**15-DAY EXPRESS TERMS  
FOR  
PROPOSED BUILDING STANDARDS  
OF THE  
DIVISION OF THE STATE ARCHITECT (DSA-AC)

REGARDING THE CALIFORNIA BUILDING CODE  
CALIFORNIA CODE OF REGULATIONS, TITLE 24, PART 2

2013 CALIFORNIA BUILDING CODE**

**Figure 11B-404.2.4.1  
Maneuvering Clearances at Manual Swinging Doors and Gates**

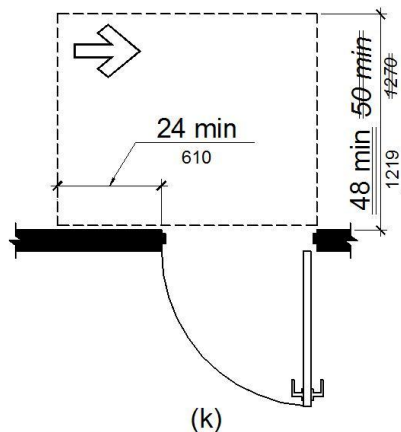
**RATIONALE:** DSA-AC is proposing an amendment to this figure to correct an inadvertent inconsistency between the figure and the corresponding table. Figure 11B-404.2.4.1(k) is being revised to show a 48" maneuvering clearance perpendicular to the doorway, reflecting the regulatory language of Table 11B-404.2.4.1.

**Figure 11B-404.2.4.3  
Maneuvering Clearances at Recessed Doors and Gates**

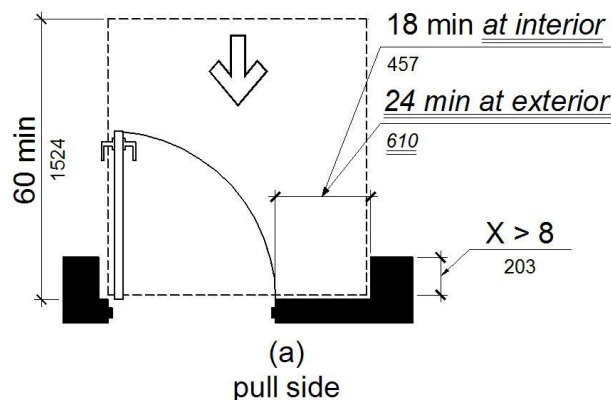
**RATIONALE:** DSA-AC received public comment stating that the language of this section is not consistent with the 2010 CBC, Sections 11B-1133B.2.4.2 and 1133B.2.4.5. The current CBC requirements provide an 18 inch maneuvering clearance at interior doors and a 24 inch maneuvering clearance at exterior doors. DSA-AC is proposing to amend 11B-404.2.4.3 and Figure 11B-404.2.4.3 to maintain the higher level of accessibility currently provided by the 2010 CBC.

**11B-404.2.4.3 Recessed Doors and Gates.** Maneuvering clearances for forward approach shall be provided when any obstruction within 18 inches (~~455~~ 457 mm) of the latch side of ~~a~~ an interior doorway, or within 24 inches (610 mm) of the latch side of an exterior doorway, projects more than 8 inches (~~205~~ 203 mm) beyond the face of the door, measured perpendicular to the face of the door or gate.

**Figure 11B-404.2.6**  
**Doors in Series and Gates in Series**

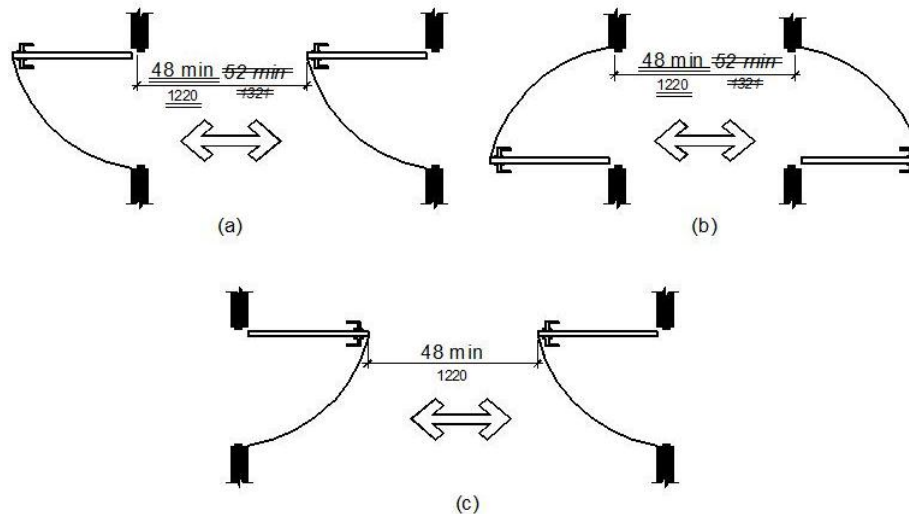
**RATIONALE:** DSA-AC is proposing an amendment to these figures to correct inadvertent inconsistencies between the figure and the corresponding text. Figures 11B-404.2.6 (a) & (b) are being revised to show a 48" maneuvering clearance at doors or gates in series, reflecting the regulatory language of 11B-404.2.6.

**11B-404.2.6 Doors in Series and Gates in Series.** The distance between two hinged or pivoted doors in series and gates in series shall be 48 inches (1219 mm) minimum plus the width of doors or gates swinging into the space.

**Figure 11B-607.2**  
**Clearance for Bathtubs**

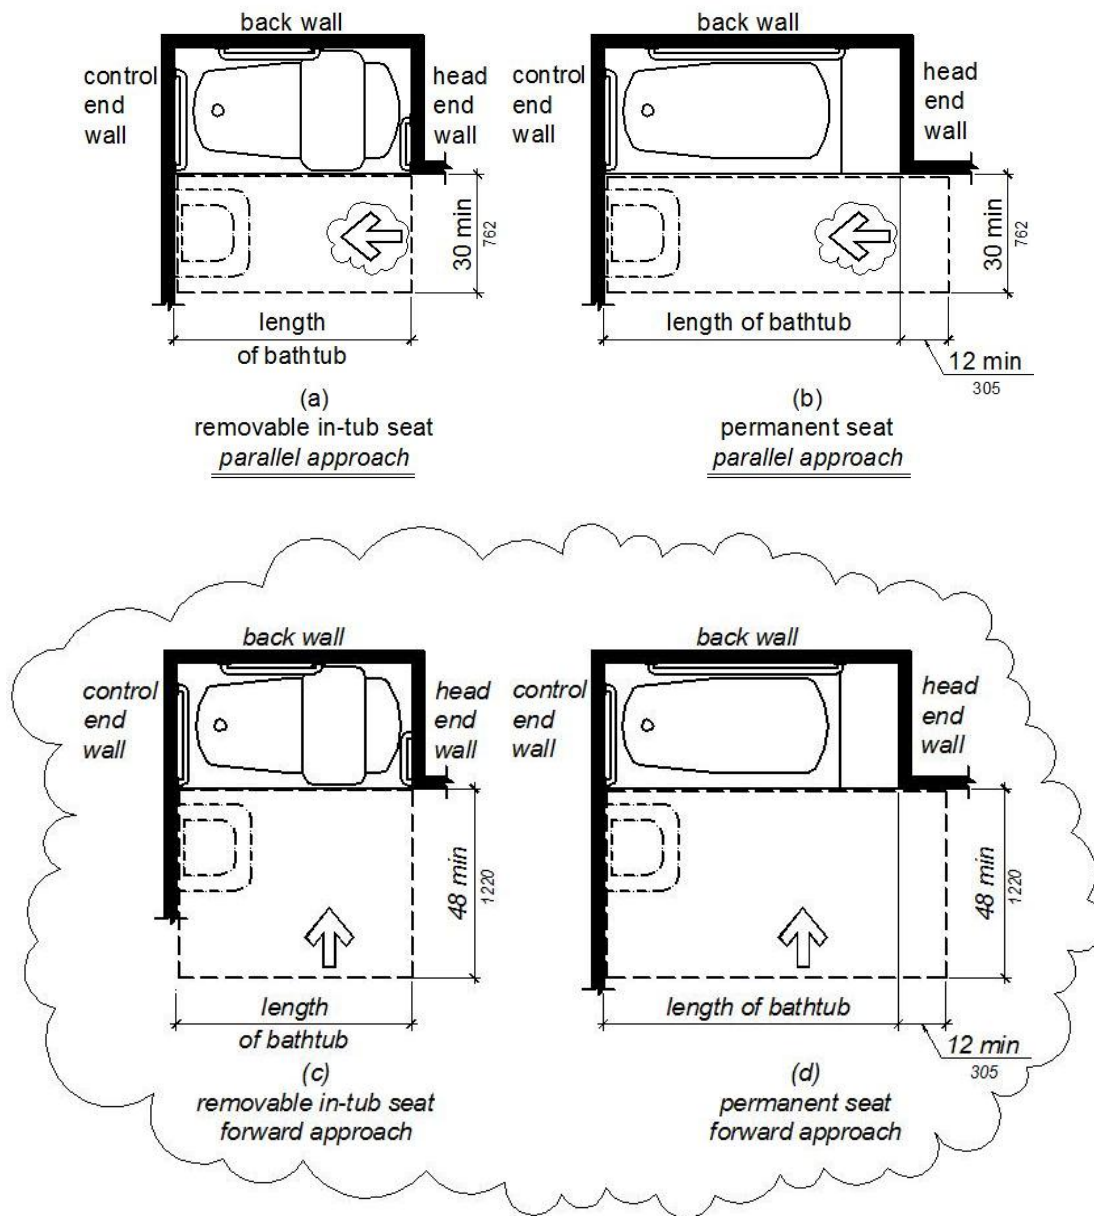
**RATIONALE:** DSA-AC is proposing to amend Figure 11B-607.2 to illustrate the clearance requirements for both forward and parallel approach consistent with the amendments proposed in the 45-day comment period. Diagrams (a) and (b) will be revised to include directional arrows indicating a parallel approach to the bathtubs. New diagrams (c) and (d) will be added indicating 48" wide minimum clearances and a forward approach to the bathtubs.

**11B-607.2 Clearance.** Clearance in front of bathtubs shall extend the length of the bathtub and shall be 48 inches (1219 mm) wide minimum for forward approach and 30 inches (762 mm) wide minimum for parallel approach. A lavatory complying with 11B-606 shall be permitted at the control end of the clearance. Where a permanent seat is provided at the head end of the bathtub, the clearance shall extend 12 inches (305 mm) minimum beyond the wall at the head end of the bathtub.
